Note: Comment responses in Red added by FAHA 5/31/16

Memorandum

Regarding: Storrs Lodge, LLC, Town of Mansfield Inland Wetland Application Review (PN: 1605880)

Date: May 12, 2016

SS-1

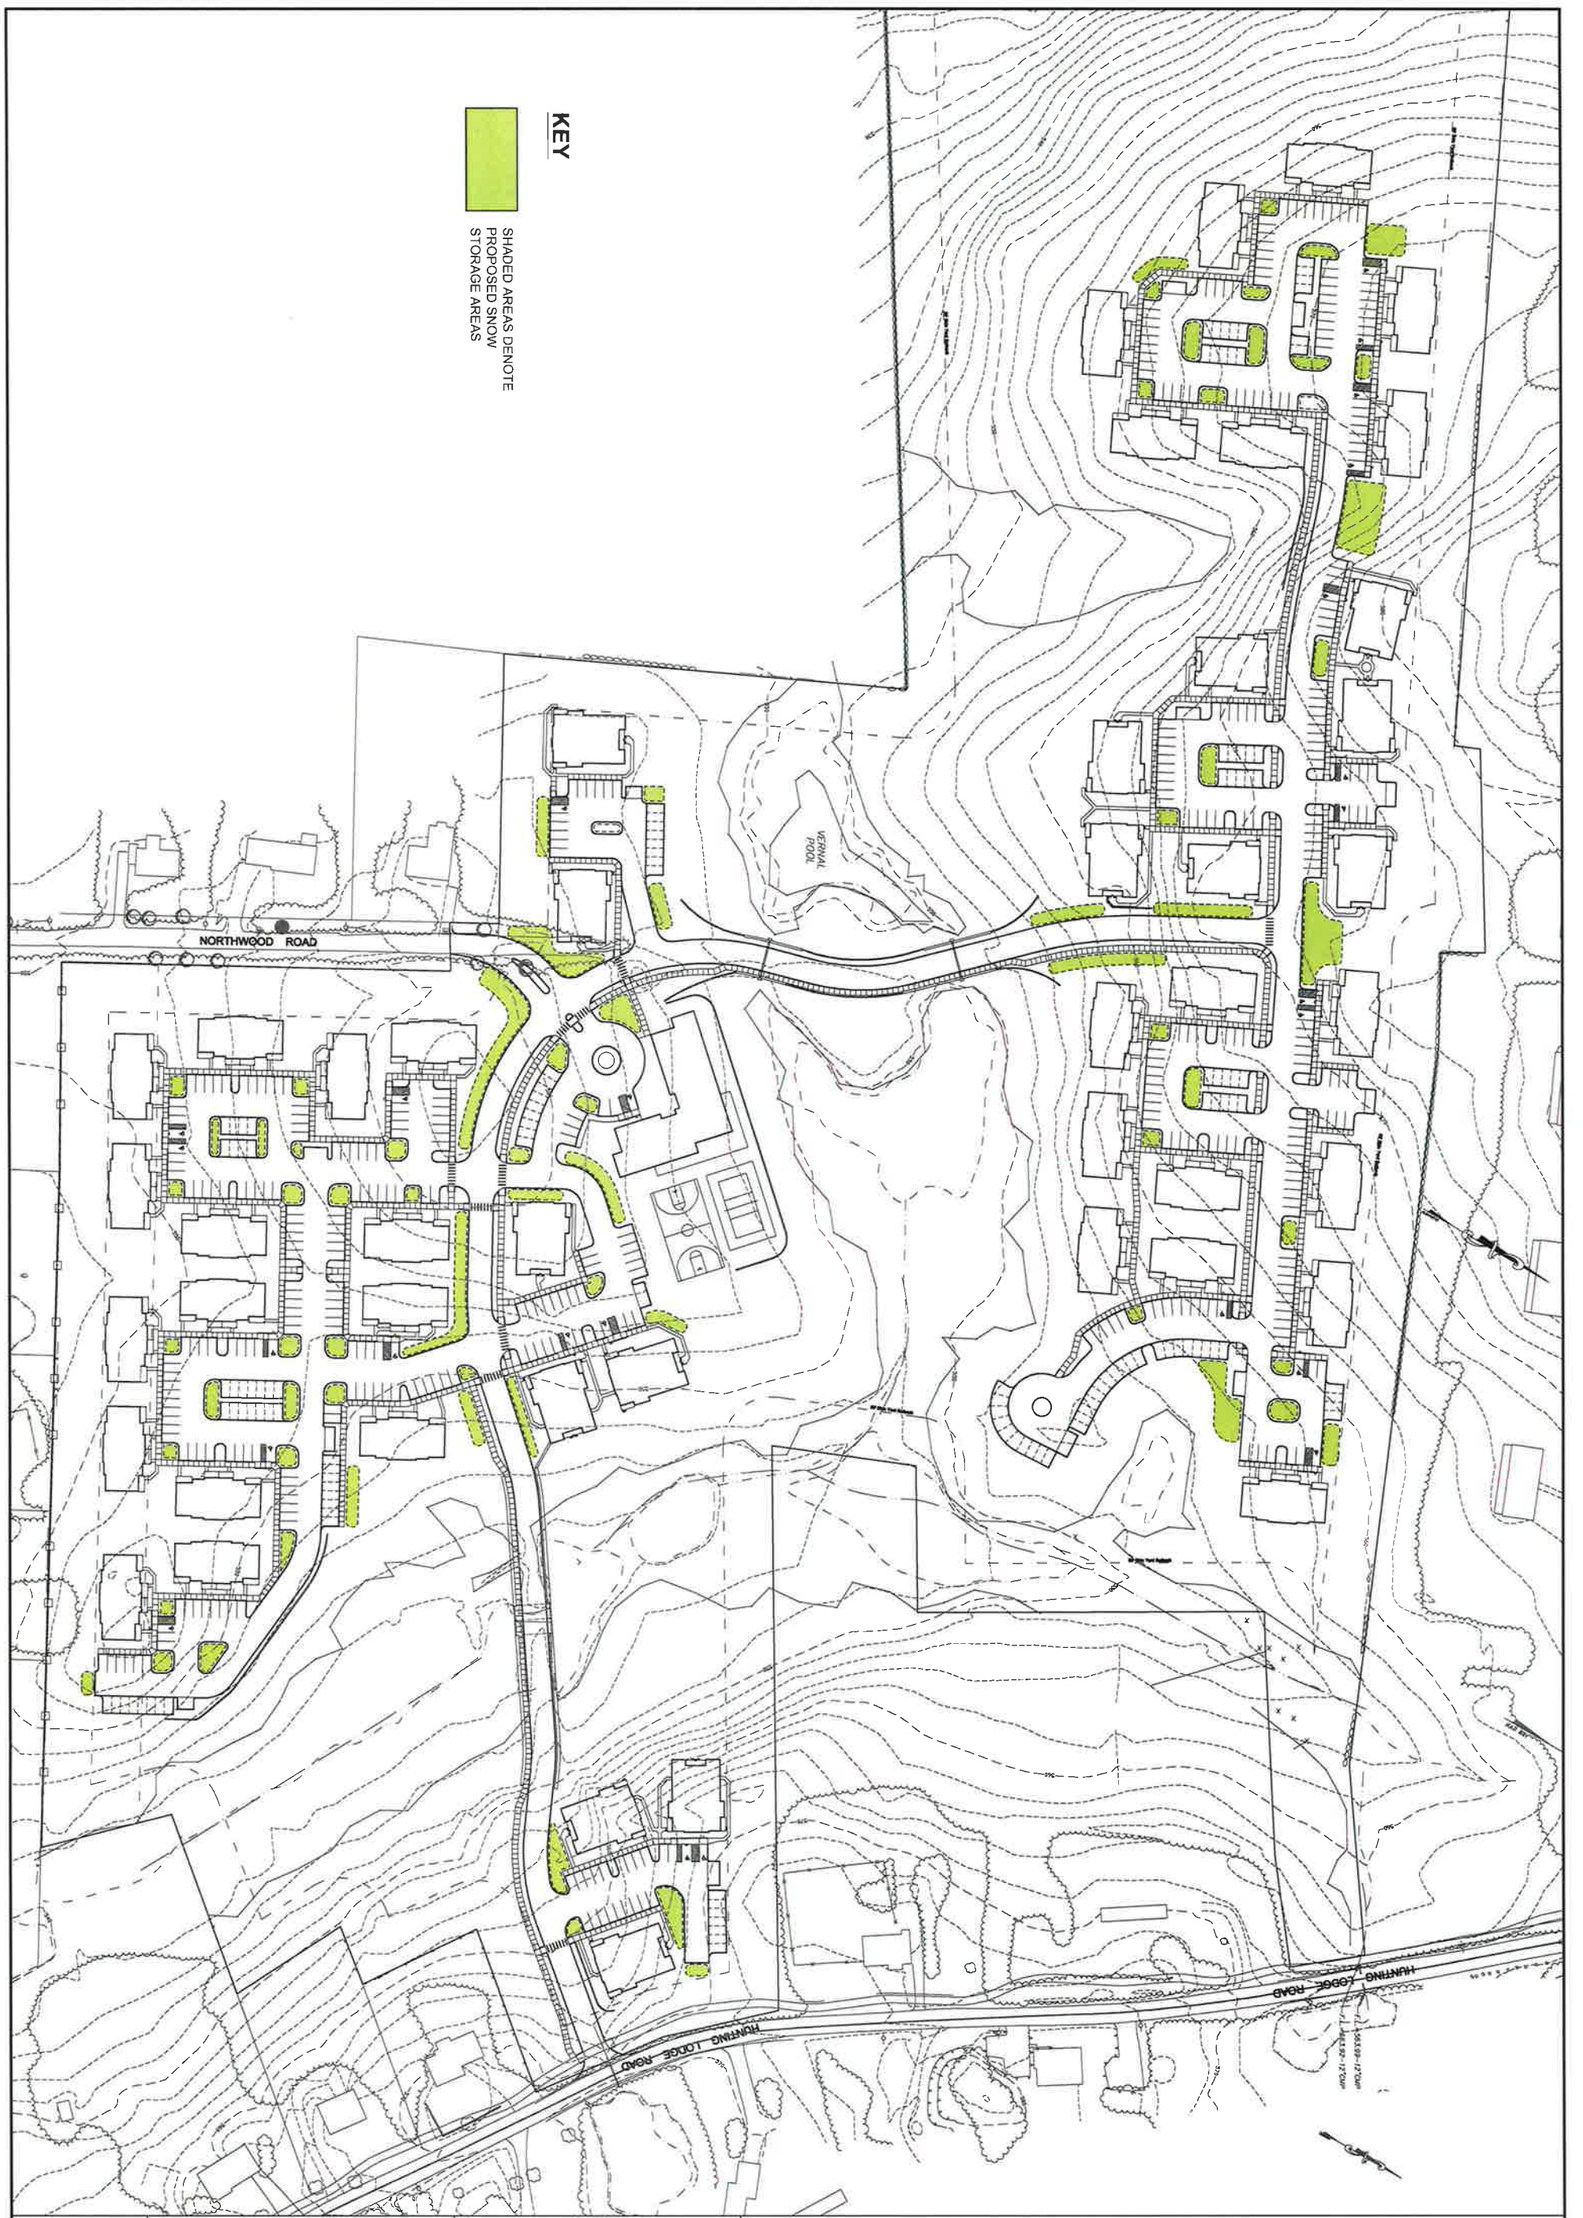
11. Proposed parking on northeast portion of the development adjacent to wetlands WC2 and WC3 will require maintenance restrictions to prevent snow management practices that may result in snow melt impacts to adjacent wetlands. It is recommended that storm water management and snow removal maintenance requirements restrict the placement of snow in this parking area, and propose guardrail placement as an engineering control measure. *As recommended, a snow management and storage plan has been developed for the entire site and is attached for review and comment. The placement of snow piles will be banned from this area in the site maintenance plan.*
